SERVICE BULLETIN

Classification: EL01-012	Reference: NTB01-037	Date: June 1, 2001
-----------------------------	-------------------------	-----------------------

2000 MAXIMA DRIVER'S FRONT POWER WINDOW - NO OPERATION

APPLIED VEHICLES: 2000 Maxima (A33)
APPLIED VINS: Vehicles built before JN1CA31A*YT027125
JN1CA31A*YT222281
JN1CA31D*YT547197
JN1CA31D*YT762425
APPLIED DATE: Vehicles built before April 3, 2000

Figure 1

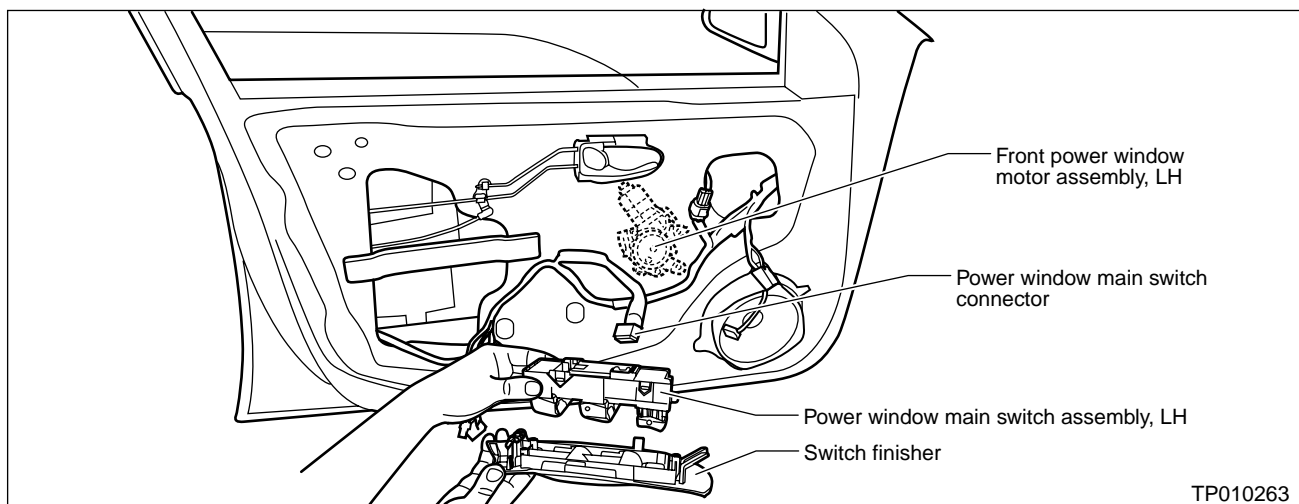
If an Applied 2000 Maxima needs power window motor replacement, the power window main switch assembly should also be replaced with one from the PARTS INFORMATION section of this bulletin. See Figure 1 for location of the front, left-hand power window motor assembly and power window main switch assembly.
